Newton County Regional Water and Sewer District

Wastewater Collection and Treatment System

Addendum No. 3

August 30, 2009

AMERICAN STRUCTUREPOINT INC	NEWTON COUNTY REGIONAL WATER & SEWER DISTRICT WASTEWATER COLLECTION & TREATMENT SYSTEM	REFERENCE SHEET DATE: 2008/08/10 SCALE: 1" = 20' JOB NO: 20080702	PROJECT NO. 1
	ADDENDUM No. 3

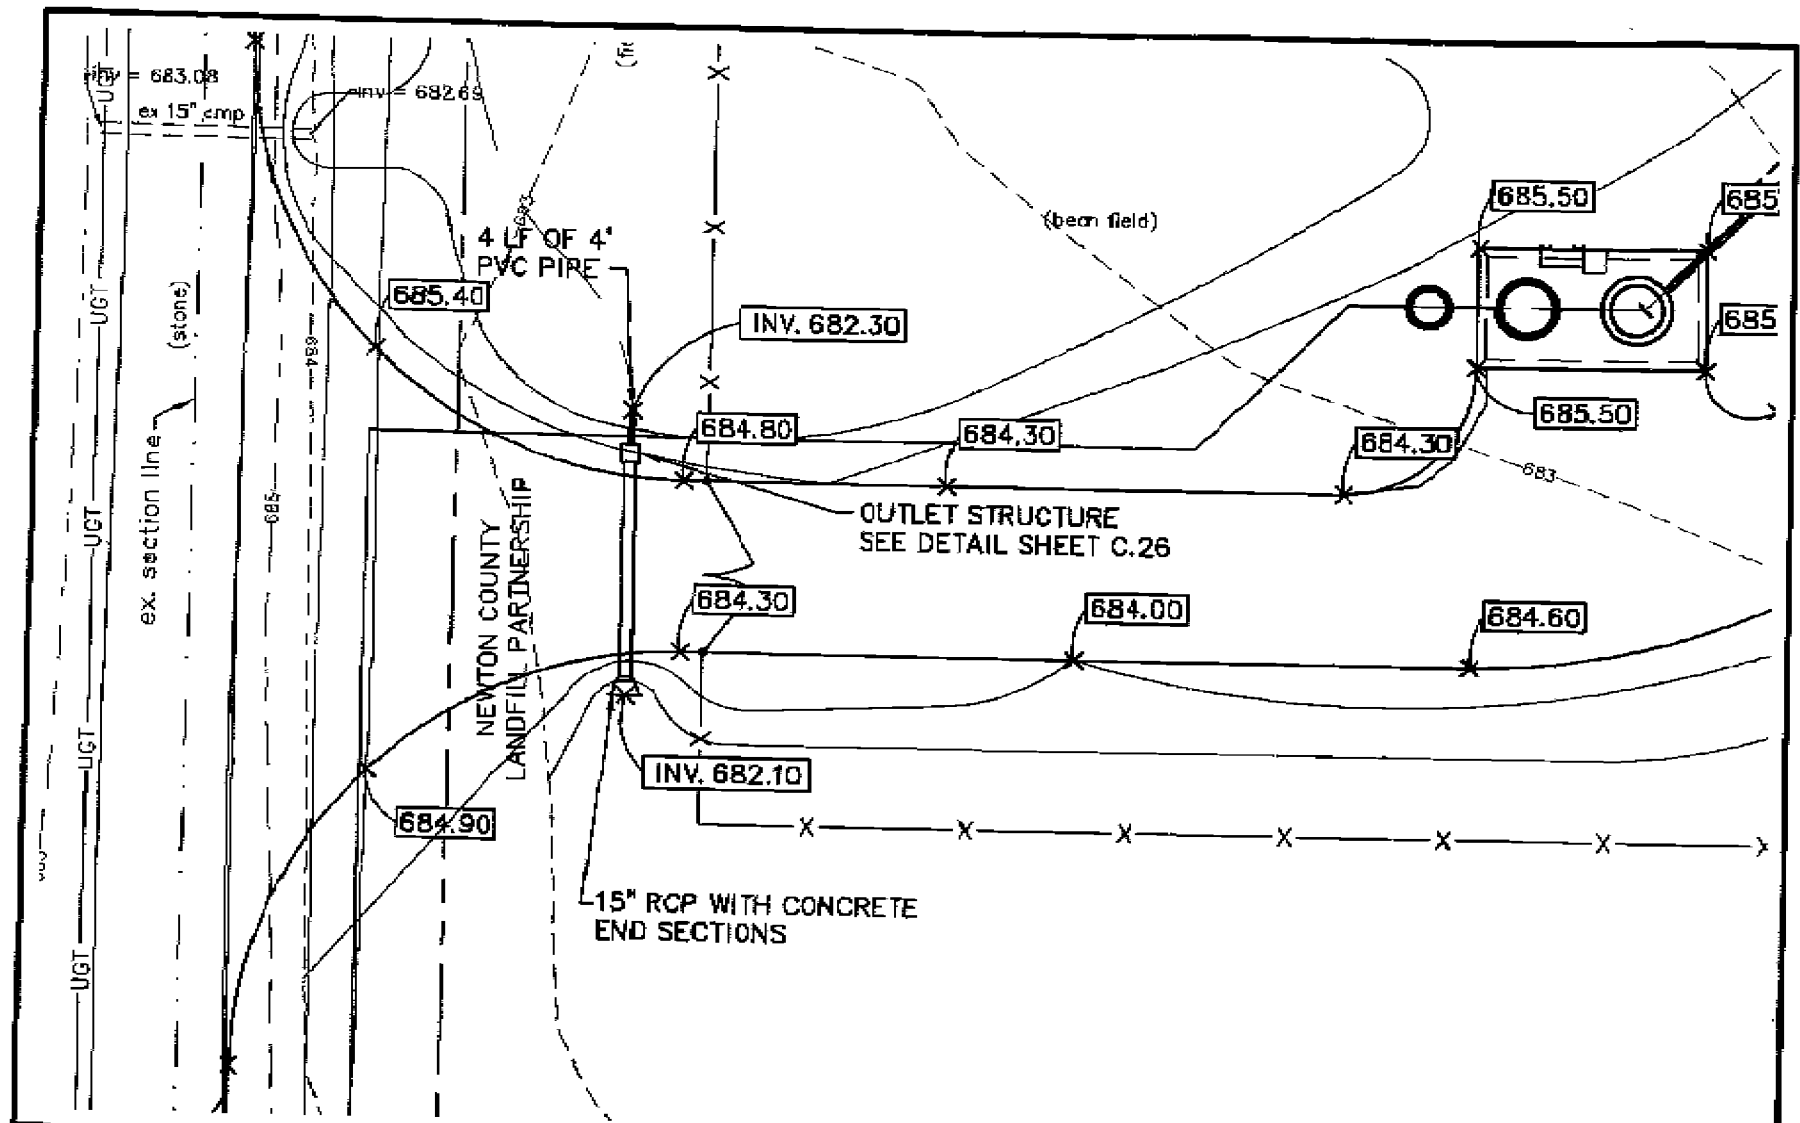
1. **MODIFY** Sheet C.2 with the Figure No. 1 attached to this Addendum.
2. **MODIFY** Sheets C.14 to C.18 by changing the low pressure force main size from 2" SDR 11 to 1.5" SDR 11.
3. **MODIFY** Sheet C.20 by changing the cascade aerator detail reference from Sheet C.6 to Sheet P.6.
